### **BOARD ACTION REPORT – APPEALABLE ITEM**

<b>Project Name:</b>	<b>222 Palm Court</b>
<b>Project Location:</b>	<b>222 Palm Court, Del-Ida Park Historic District</b>
<b>Request:</b>	<b>Certificate of Appropriateness (2019-299)</b>
<b>Board:</b>	<b>Historic Preservation Board</b>
<b>Meeting Date:</b>	<b>October 2, 2019</b>

## HISTORIC PRESERVATION BOARD STAFF REPORT

### 222 Palm Court

Horizontal Rollers - Orange  
Single Hung - Yellow

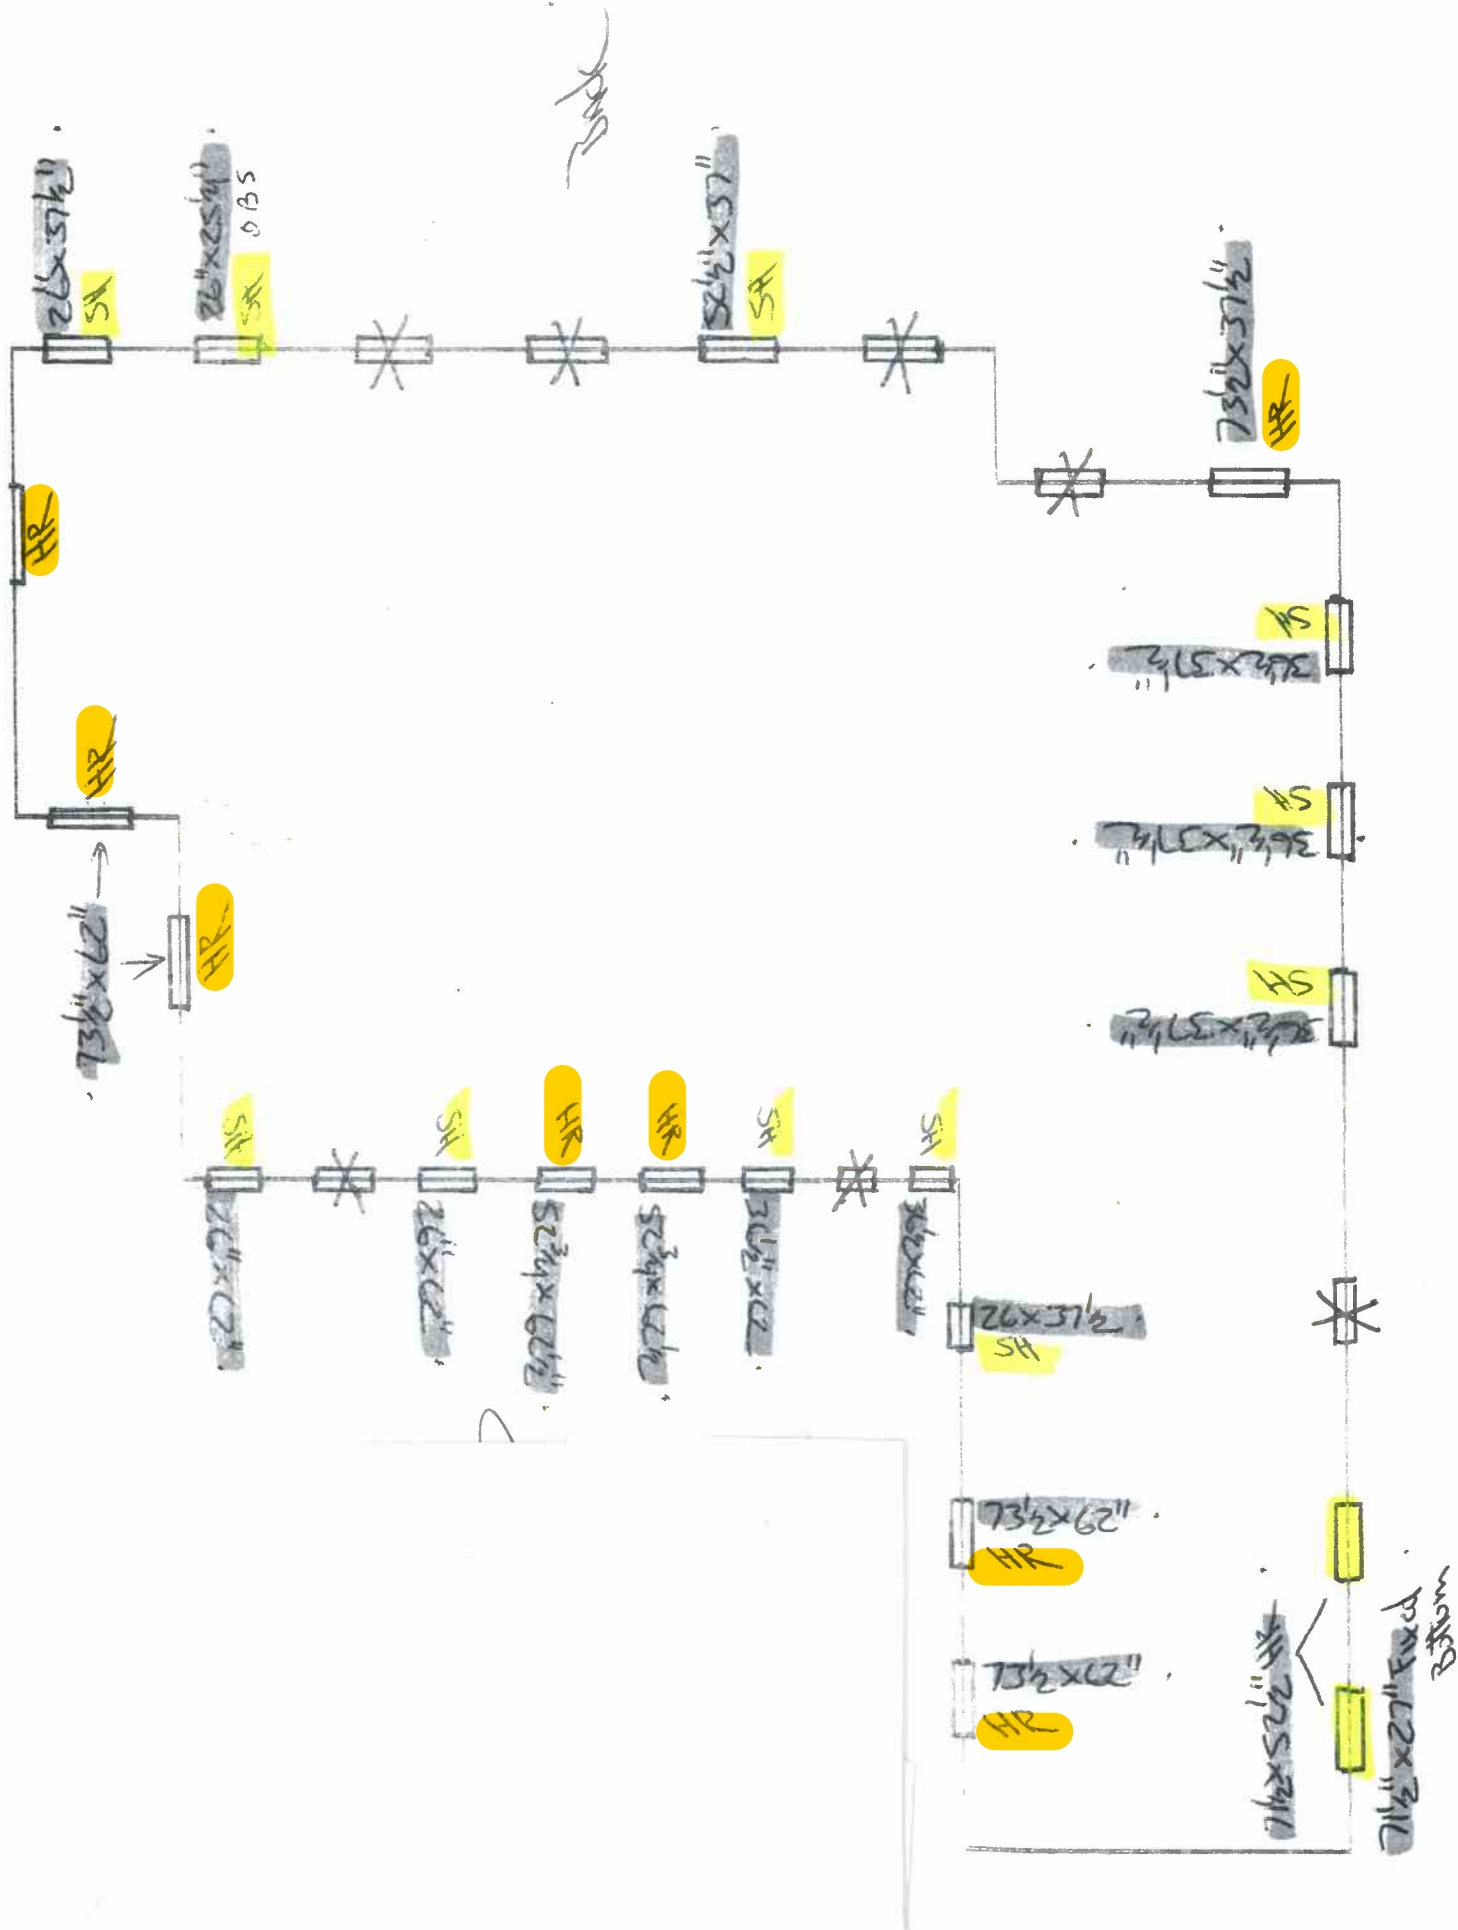
The proposal is for replacement of 8 windows with horizontal sliding windows – 1 on the front elevation and 7 on the side and rear elevations. It is noted that 13 of the 21 total windows are being replaced with single-hung windows, which is being processed via building permit. Overall, the window replacement project will help to restore some architectural authenticity.

Based upon the above standards, guidelines, and requirements the use of single-hung or casement windows is most appropriate for use with the subject structure, but given the fact that the original form and architectural style of the structure no longer exists the use of 8 horizontal sliding windows, with 1 such window on the façade, can be deemed appropriate. Overall, the window replacement project will help to restore some architectural authenticity as 13 of the 21 windows are single-hung windows and muntins are proposed on the 8 horizontal sliding windows, giving the appearance of a divided lite window.
